Access Compliance Report

Public Rights-of-Way

Intersection ID: 46787	Main Street: STOWE_ACRES_DR	Cross Street: MALLARD_WOODS_PL	Location: NW
ADA ID: 3A914707A39D	Ramp Type: PerpDiag	Initial Pass/Fail: Fail	Overall Compliance: No
Severity Score: 21.25			
Codes/Mitigation Info/Possible Solution		Field Measurements/Component Compliance

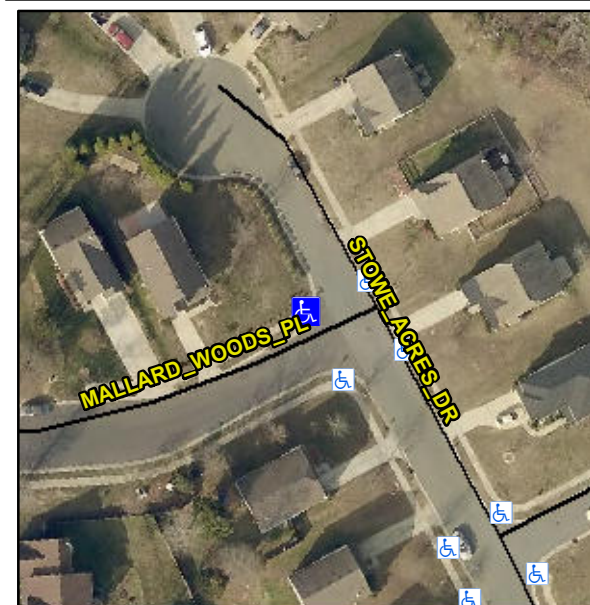
Not Found, R304.5.1, R304.5.3

Compliance	Description	Data	Compliance	Description	Data
N/A	Ramp Length (in)	44.5	Yes	Ramp Slope (%)	5.5
No	Ramp Width (in)	38.0	No	Ramp XSlope (%)	5.2
N/A	Flare Type LT	N/A	N/A	Flare Type RT	N/A
N/A	Flare Slope LT (%)	N/A	N/A	Flare Slope RT (%)	N/A
N/A	Flare Traversable LT?	N/A	N/A	Flare Traversable RT?	N/A
N/A	Landing Length (in)	N/A	N/A	DWS Provided?	N/A
N/A	Landing Width (in)	N/A	N/A	DWS Contrast?	N/A
N/A	Landing Slope (%)	N/A	N/A	DWS Length (in)	N/A
N/A	Landing X Slope (%)	N/A	N/A	DWS Full Width?	N/A
N/A	Landing Curb? (Y/N)	N/A	N/A	DWS Offset (in)	N/A
N/A	Shared Landing?	N/A			
N/A	Gutter Ponding?	N/A	N/A	Gutter Slope (%)	N/A
N/A	Gutter Lip Ht (in)	N/A	N/A	Gutter X Slope (%)	N/A
N/A	Painted X Walk1?	No	N/A	Painted X Walk2?	No
	X Walk 1 Direction	To S		X Walk 2 Direction	To E
N/A	X Walk 1 Width (in)	N/A	N/A	X Walk 2 Width (in)	N/A
	X Walk 1 Slope (%)	0.9		X Walk 2 Slope (%)	4.4
	X Walk 1 X Slope (%)	1.8		X Walk 2 X Slope (%)	2.0

Remove & Replace Curb Ramp With Two New Directional Ramps or Equivalent.
